REGULATORY COMMITTEE RESPONSE TO U S EPA REGION IV COMMENTS ON
CORRECTIVE MEASURES STUDY WORK PLAN ZONE I CNC CHARLESTON SC

Re: Response to Comments on the Zone I CMS Work Plan

**Response to EPA Comments on the
Corrective Measures Study Work Plan – Zone I
Charleston Naval Complex
North Charleston, South Carolina
Dated February 2002**

Attachment 1
Proposed Confirmation Surface Soil and
Subsurface Soil Sampling Locations
AOC 680, Zone I
Charleston Naval Complex

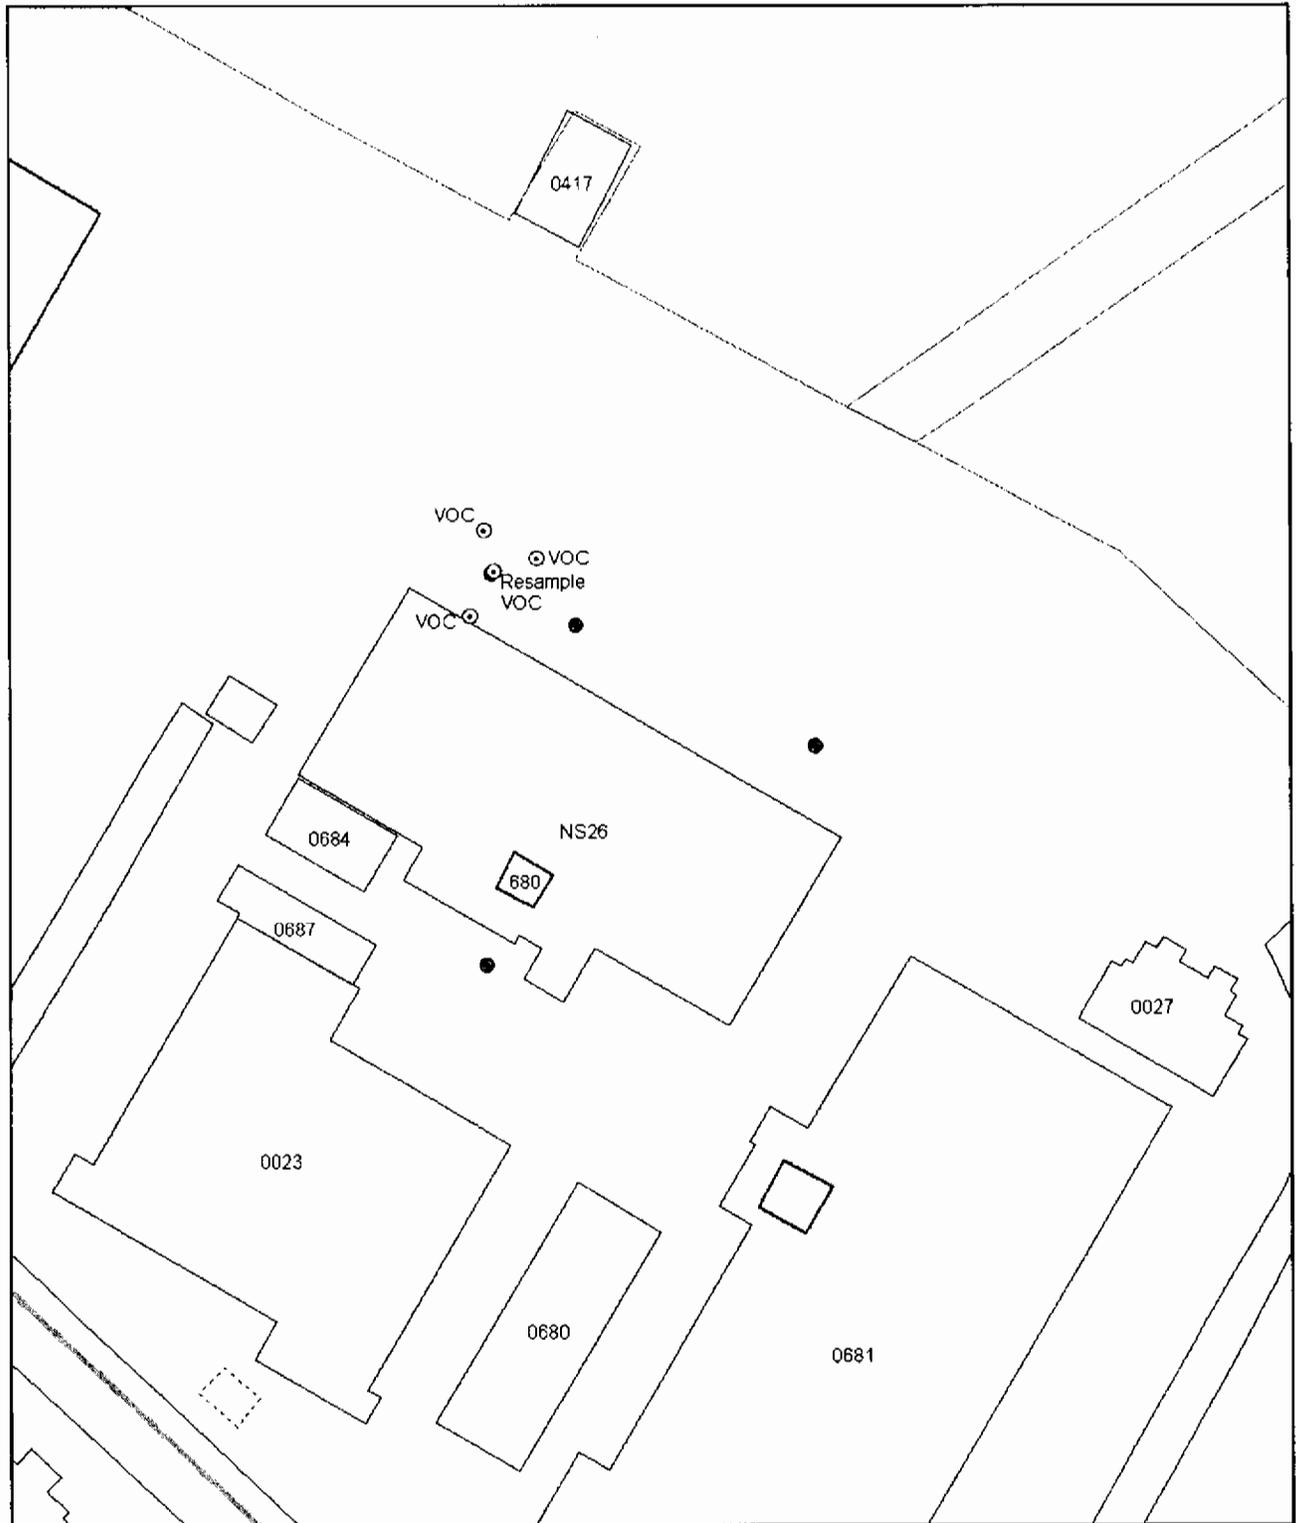
4. **Section 6.3.2.1, Page 6-6.** The report states that 1,2-dichloroethene was detected in surface and subsurface soil in the same boring at concentrations greater than the SSL. Since 1,2-dichloroethene was not detected in groundwater at a co-located well and the concentrations are only slightly above the SSL, the report concludes that 1,2-dichloroethene is not a COC. However, the nearest soil sample is approximately 50 feet from the detection location. Additional soil sampling may be required to adequately determine that 1,2-dichloroethene is not present at concentrations of concern.

CH2M-Jones proposes to resample surface (0 – 1 ft bls) and subsurface (3 – 5 ft bls) soil at the location adjacent to well I680GW004 and analyze the samples for VOCs to assess current soil conditions. In addition, surface and subsurface soil samples will be collected at three locations approximately 20 feet from I680GW004. One soil sampling location will be upgradient of the well and two will be downgradient. Attachment 1 is a figure that shows the specific proposed sampling locations.

After collection and analysis of these samples, a CMS Work Plan addendum for AOC 680 will be prepared. The results will be evaluated to assess whether VOCs in surface or subsurface soil should be considered COCs. If VOCs are determined to be COCs at the site, a pathway forward for additional activities, which may include more soil or groundwater sampling, will be developed, after consultation with EPA.

Arsenic as a function of Iron Concentration (ug/L)
At Well I687GW002

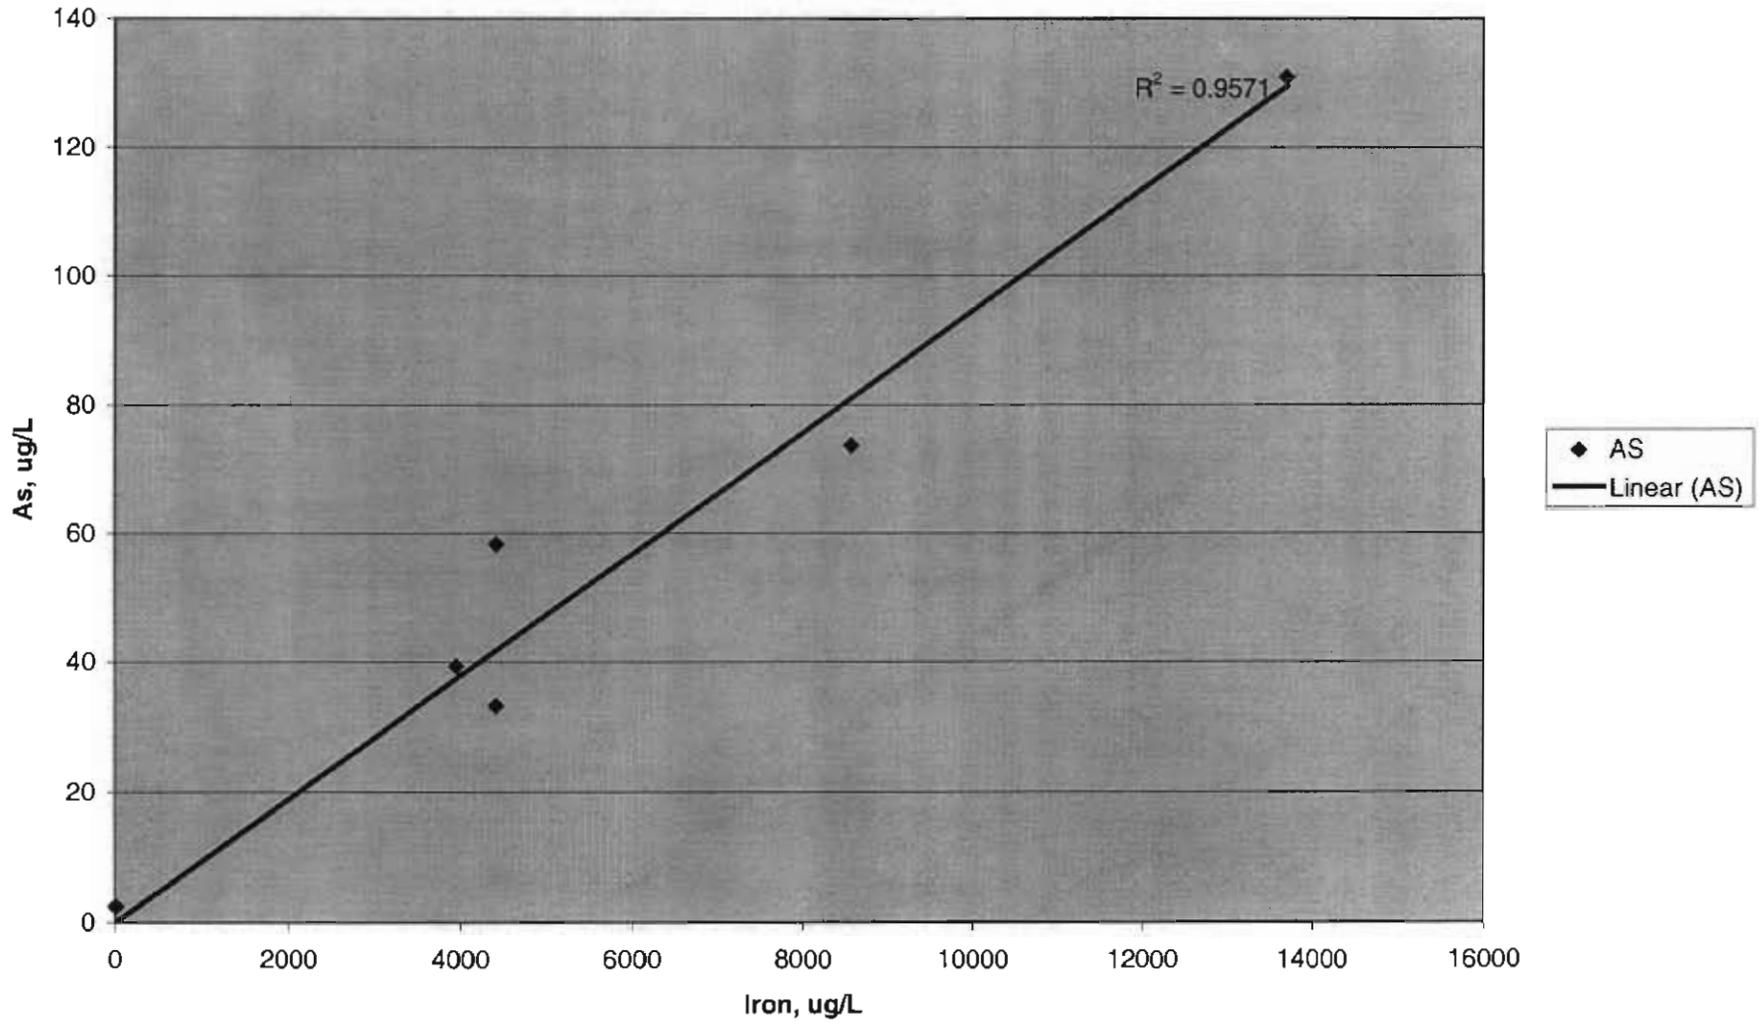
6. **Section 9.3.3.1, Page 9-6.** The report indicates that when well I687GW002 was re-sampled in 1999, the concentration of arsenic had decreased to 26.7 micrograms per liter (ug/L). However, this result could not be located on the tables provided. Please provide this data, since it is used to conclude that arsenic in groundwater at AOC 687 is not a COC. Please provide a description of the sampling technique, since this can significantly impact inorganic compound results. For example were low flow purging/sampling techniques used in more recent sampling events?

Also, Attachment 3 to this Response to Comments is a figure that plots arsenic versus iron concentrations in groundwater samples from well I687GW002 (except for the 1999 data point, for which iron was not measured). The figure shows a linear regression for the data, with an R-squared value of 0.957, a remarkably good coefficient for groundwater data of this type. The regression shows a significant relationship between arsenic and iron, strongly confirming the probability that the arsenic is present due to natural geochemical processes.

Based on these considerations, we believe that arsenic is not site related and should not be considered a COC for this site.

Arsenic Versus Iron in Groundwater at SWMU 12

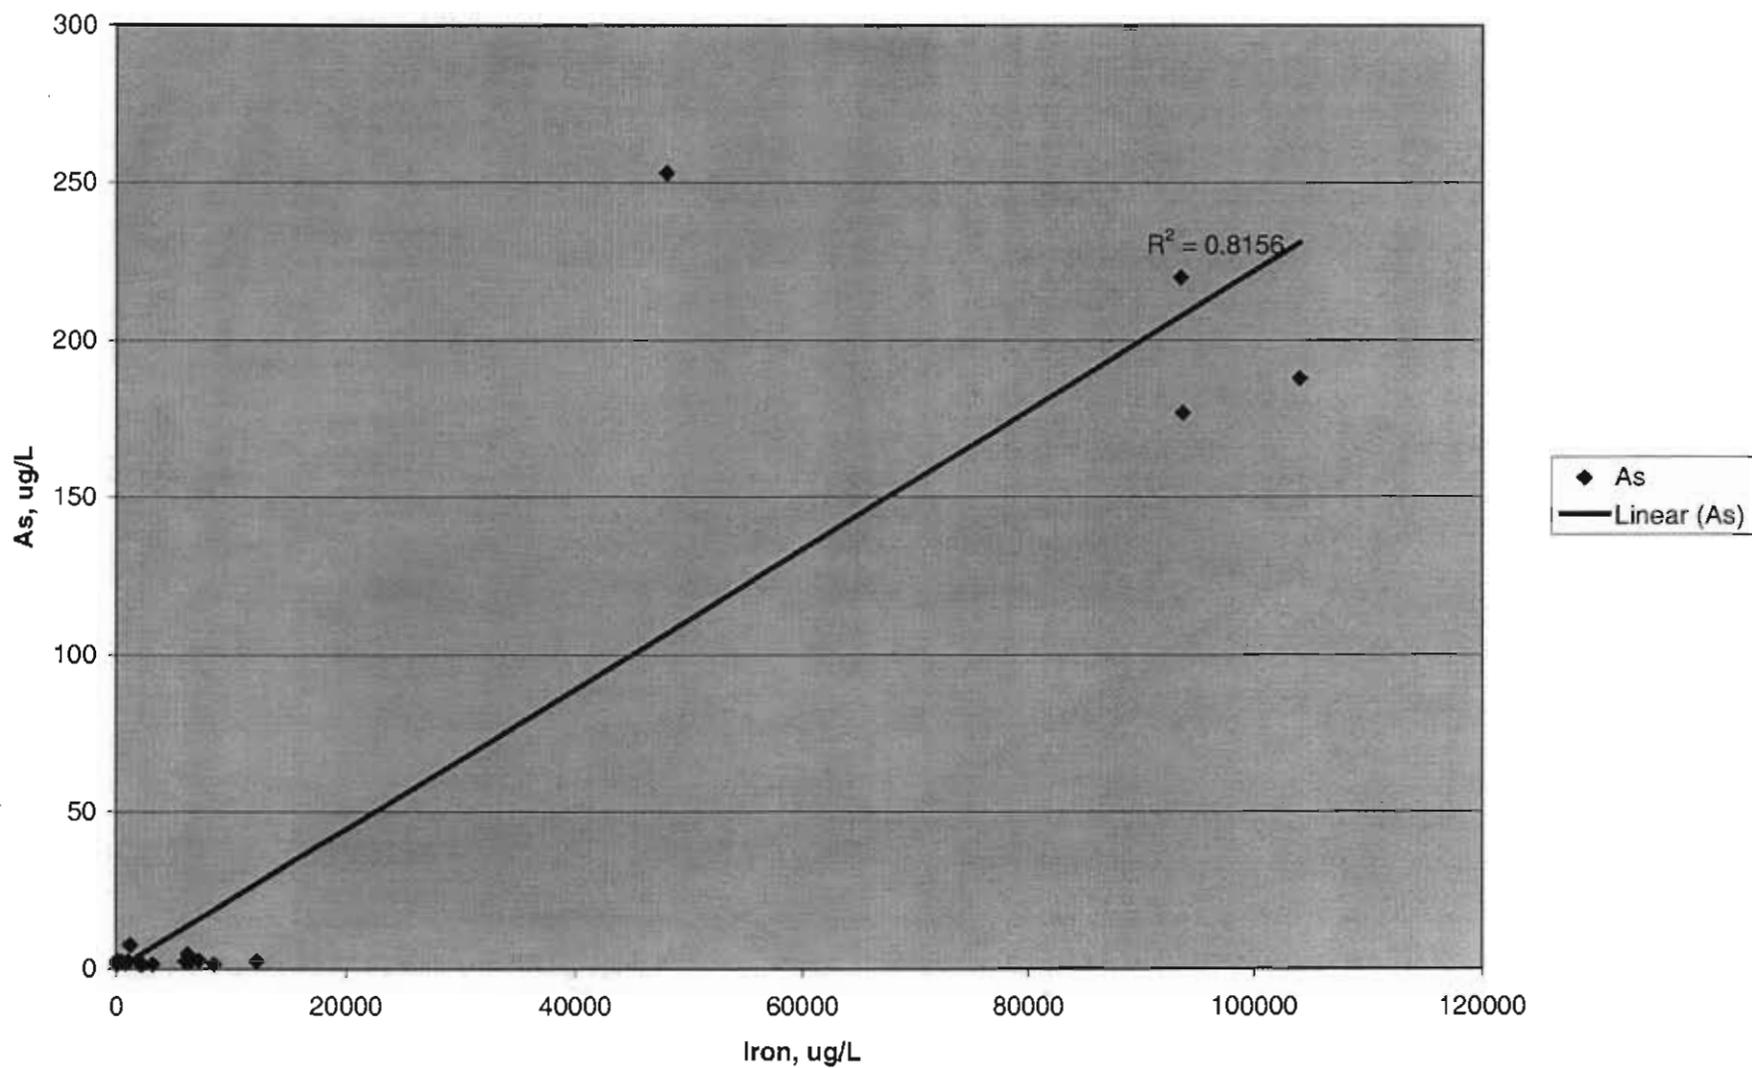
8. **Section 12.3.3.1, Page 12-4.** The report concludes that elevated arsenic concentrations detected in well I012GW002 (128 to 253 ug/L) are from natural background sources based on the presence of arsenic in background grid wells and elevated iron and manganese concentrations in groundwater at well I012GW002. The 1999 data could not be located on the tables provided. Please provide this data, since it is used to conclude that arsenic in groundwater is not a COC. Also, the concentration of arsenic in groundwater at this well is 2 to 4 times the maximum concentration detected in grid wells (66 ug/L). While iron and manganese concentrations are also many times higher than the concentrations detected at other wells, re-sampling of the well using low flow purging/sampling is recommended to confirm the results.

The arsenic data for 1999 were inadvertently omitted from Table 9-10. The table will be revised to include the 1999 arsenic results. Also, Attachment 4 to this Response to Comments is a figure that plots arsenic versus iron concentrations in groundwater samples collected at SMWU 12. The figure shows a linear regression for the data, with an R-squared value of 0.8159, which is a remarkably good coefficient for groundwater data of this type.
